TO: Service Locations

FROM: Service Systems Development

SUBJECT: **DD Heavy Duty Platform Belt Tensioner Change**

**Fig. 2, New Friction Damping Tensioner**

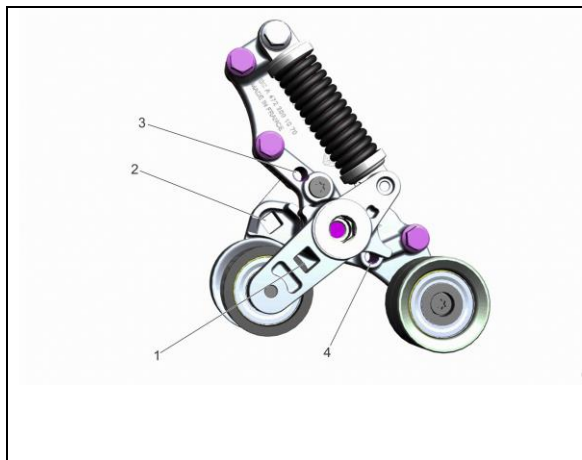
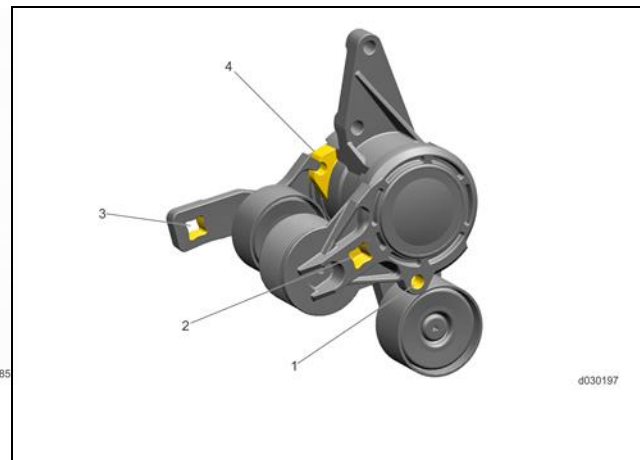
A newly designed, dual-arm friction shoe damping tensioner was implemented for the DD Heavy Duty Platform. New tensioner P/N: A4722001370 was released to engine production on December 7th, 2018, with approximate engine serial number HDE0644305 for current USA/Canada and export engines. Belt lengths and maintenance interval per application and engine variance did NOT change. For current belt information, reference Technical Service letter 18 TS-4rev. New sections in the appropriate workshop and troubleshooting manuals have been created. The new sections are labeled “Friction Belt Tensioner”. The tensioner should only be replaced if indicated by the appropriate troubleshooting manual procedure.

**The new friction damping tensioner is not backwards-compatible with certain vehicles built before November 1, 2017.** The new tensioner can be used in all vehicles built on or after November 1, 2017. Certain vehicles built before November 1, 2017 will continue to use the hydraulic damping tensioner. Refer to Chart 1 for part numbers.

**Selecting the incorrect tensioner may prevent proper installation due to interference between the tensioner and the fan clutch. This interference may be difficult to identify visually.**

**All vehicles built on or after November 1, 2017 should use the Friction Damping Tensioner. Refer to Chart 1 for part numbers.**

**Fig. 9, Friction Damping Tensioner Enhancement Description**

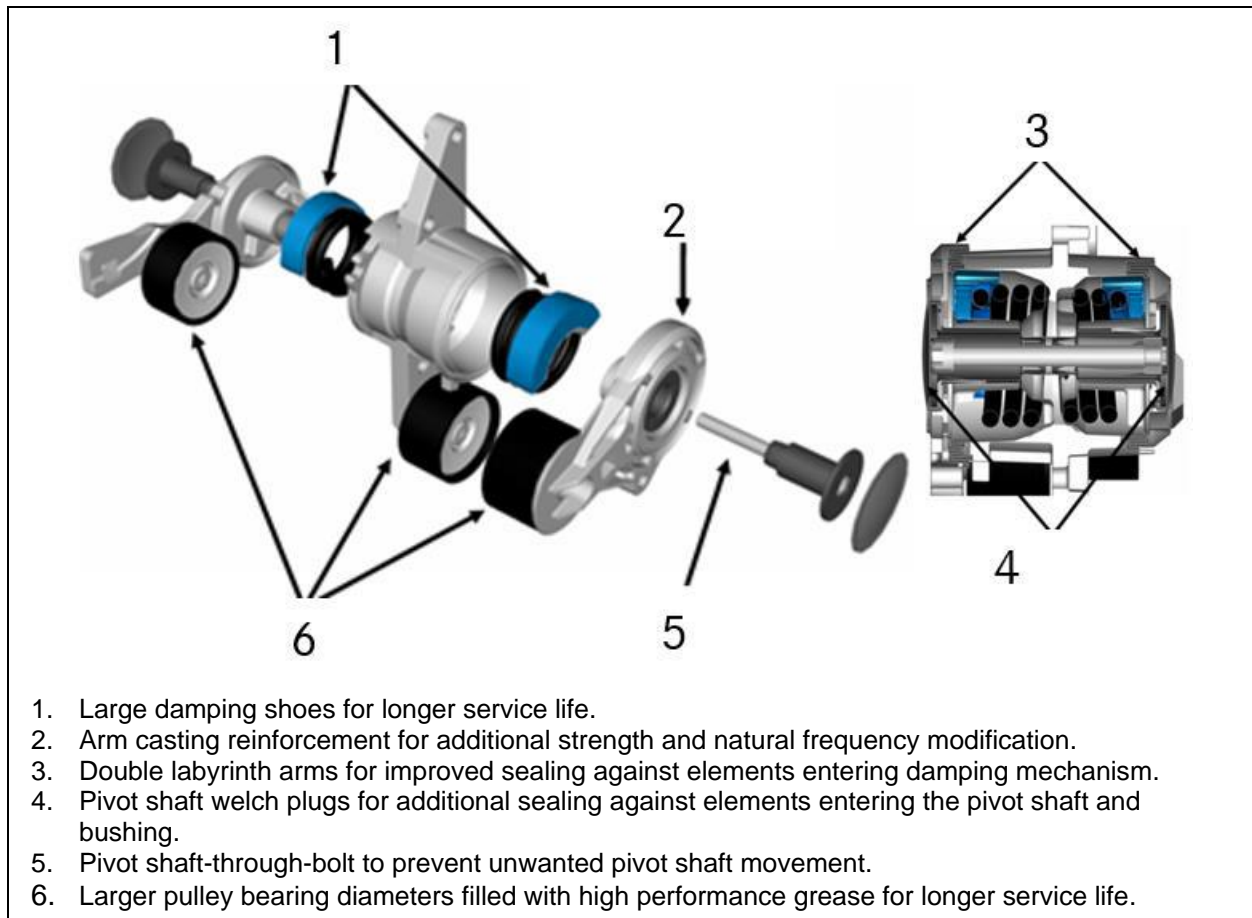
Detroit™ recommends using the new friction damping tensioner, **when applicable and according to Chart 1**. The new belt tensioner has been through vigorous testing to optimize functionality and reliability. The following components have been optimized for the new friction damping tensioner.
